# DWDM black link adjacent channel spectral isolation for 802.3cw

Supporting contribution for D2.4 comment 1

IEEE P802.3cw

September 25, 2023

# Filter Shape

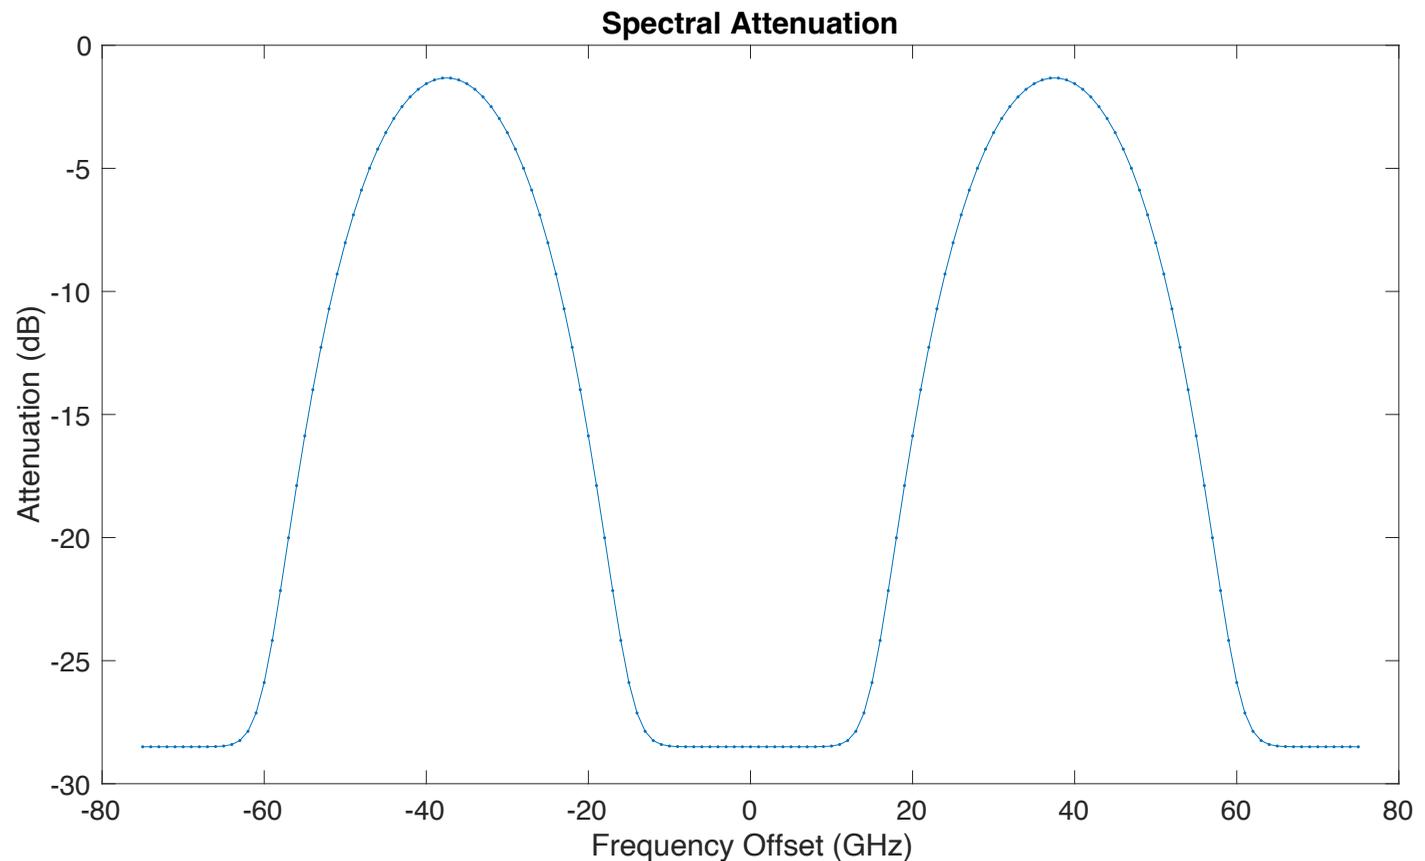
Fig 156-8 should be replaced with a figure based on the actual values. Current figure is illustrative but not sufficiently accurate.

*SuggestedRemedy*  
Update Fig 156-6 with a more accurate figure.

Replace Fig 156-6 with the figure from this contribution
